Hamburg Township Zoning Board of Appeals Wednesday, May 13, 2020 Electronic Meeting, pursuant to Executive Order 2020-48

Hamburg Zoning Board of Appeals Staff Report Staff Report

SUBJECT: ZBA 20-002

Addendum for May 13, 2020 hearing

EXHIBIT C: grading Plan

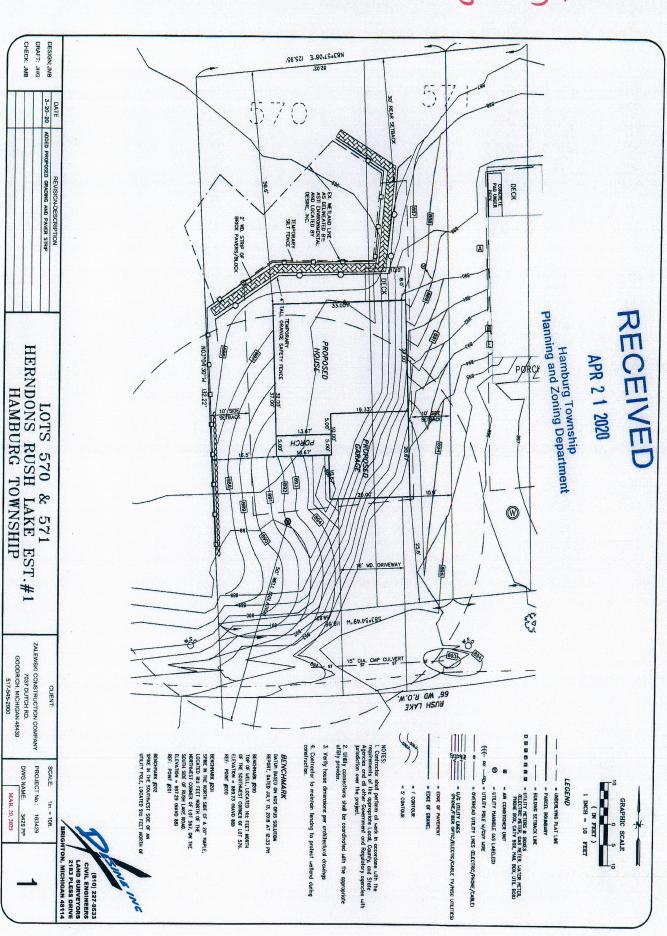
I do not have any concerns regarding the wetland delineation for the site. However, the plan for the proposed house does not include a grading plan. While the proposed house will technically be outside of the wetland, will they be proposing to fill the wetland to achieve grade for the foundation? I would recommend having them provide a grading plan.

EXHIBITB: siteplan

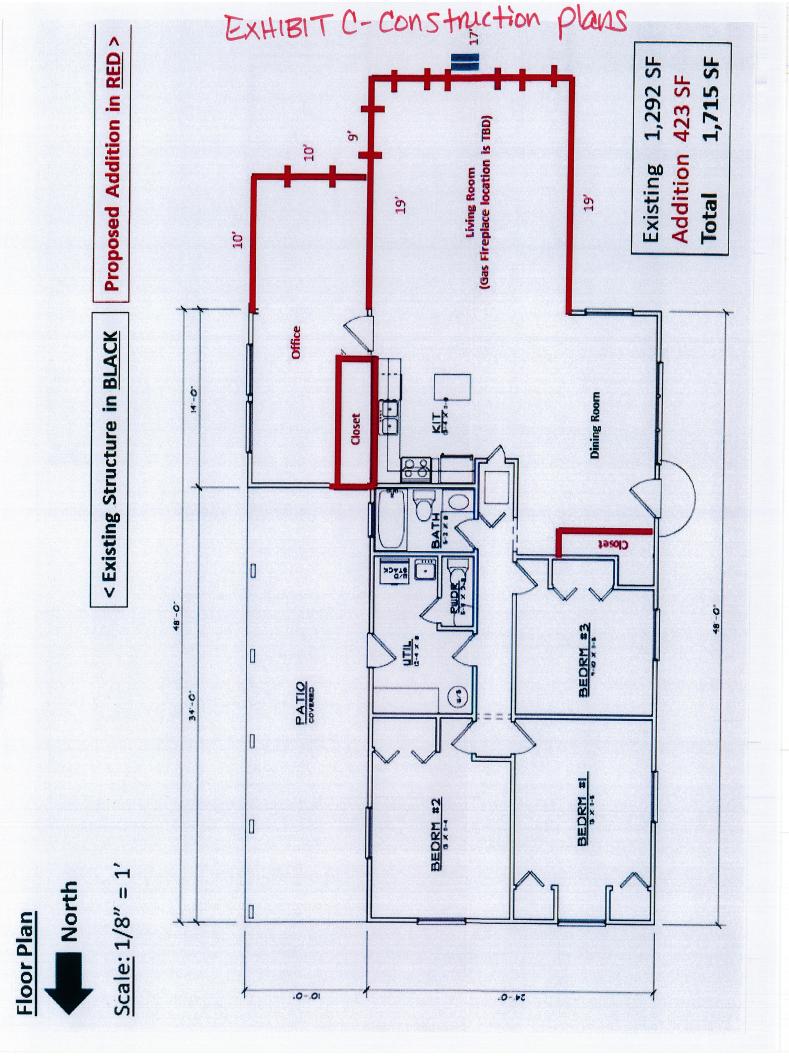
• The property owners have submitted a proposed site plan showing eight (8) feet from the grinder pump station and sewer service lateral from the existing structure. The new proposed addition will not interfere in the grinder pump station or sewer service lateral location.		
 Based on the "as-built" drawing for the grinder pump station and sewer service lateral locations, the requested variance to construct the 423 sq. ft. addition will not interfere with the sanitary sewer structures.
